Product Change Notice (PCN)

Subject: Assembly site transfer for Low Power SRAM 48-ball FBGA products

Publication Date: 2/6/2025

Part Number : RMLV0416EGBG-4S2, RMLV0816BGBG-4S2, RMLV1616AGBG-5S2/-4U2/-5U2

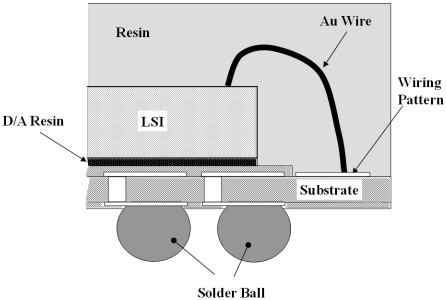
Item		Pre-change (ATJ-Kumamoto)	Post-change (GTK)	
Orderable Part Number (Tray = Tray packing, T&R = Tape & Reel packing)		RMLV0416EGBG-4S2#AC0 (Tray)	No change	
		RMLV0416EGBG-4S2#KC0 (T&R)	No change	
		RMLV0816BGBG-4S2#AC0 (Tray)	No change	
		RMLV0816BGBG-4S2#KC0 (T&R)	No change	
		RMLV1616AGBG-5S2#AC0 (Tray)	No change	
		RMLV1616AGBG-5S2#KC0 (T&R)	No change	
		RMLV1616AGBG-4U2#AC0 (Tray)	No change	
		RMLV1616AGBG-4U2#KC0 (T&R)	No change	
		RMLV1616AGBG-5U2#AC0 (Tray)	No change	
		RMLV1616AGBG-5U2#KC0 (T&R)	No change	
Assembly site		Amkor Technology Japan, Inc. Kumamoto	Greatek Electronics Inc.	
JEITA Package Code		P-TFBGA48-7.5x8.5-0.75	No change	
Package marking specification (example)			No change in specification	
Inside structure of package			No change in specification	
Assembly material	Substrate	Material	Glass epoxy	Glass epoxy
		Pattern Layout	Current specification	New specification
	Solder ball		Sn-3Ag-0.5Cu	Sn-3Ag-0.5Cu

Dia bonding		Epoxy paste	Epoxy paste
	Wire bonding		Au	Au
	Mold		Epoxy resin (Halogen-free)	Epoxy resin (Halogen-free)
Die thickness		200μm	203μm	
Final test site		Powertech Technology Inc. (Taiwan)	No change	
Packing specification		Current specification	No change	
Moisture-proof performance		MSL 3	No change	
Shipping label (*1)		Current specification	No change in format (Changes in internal code and country of origin)

Part Number : RMLV3216AGBG-5S2

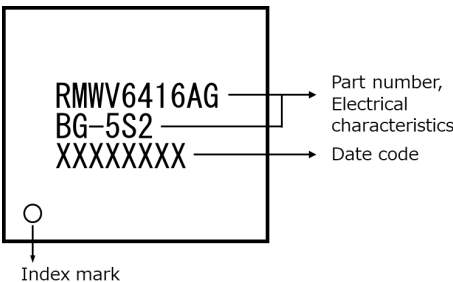
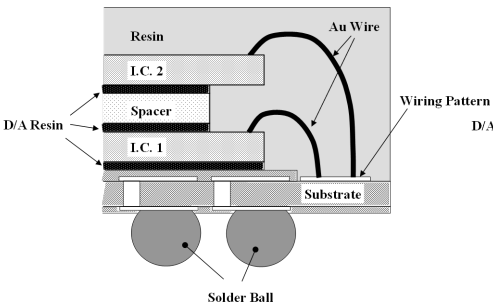
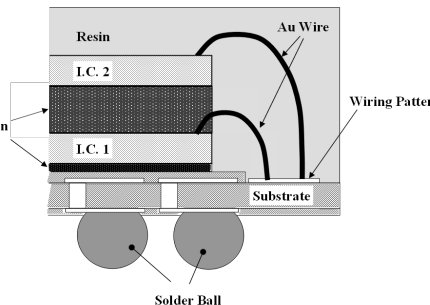
Item		Pre-change (ATJ-Kumamoto)	Post-change (GTK)	
Orderable Part Number (Tray = Tray packing, T&R = Tape & Reel packing)		RMLV3216AGBG-5S2#AC0 (Tray)	No change	
		RMLV3216AGBG-5S2#KC0 (T&R)	No change	
Assembly site		Amkor Technology Japan, Inc. Kumamoto	Gretek Electronics Inc.	
JEITA Package Code		P-TFBGA48-7.5x8.5-0.75	No change	
Package marking specification			No change in specification	
Inside structure of package			No change in specification	
Assembly material	Substrate	Material	Glass epoxy	Glass epoxy
		Pattern Layout	Current specification	New specification
	Solder ball		Sn-3Ag-0.5Cu	Sn-3Ag-0.5Cu
	Dia bonding		Epoxy paste	Epoxy film
	Wire bonding		Au	Au
	Mold		Epoxy resin (Halogen-free)	Epoxy resin (Halogen-free)
Die thickness		200μm	102μm	
Final test site		Powertech Technology Inc. (Taiwan)	No change	
Packing specification		Current specification	No change	
Moisture-proof performance		MSL 3	No change

Shipping label (*1)		Current specification	No change in format (Changes in internal code and country of origin)
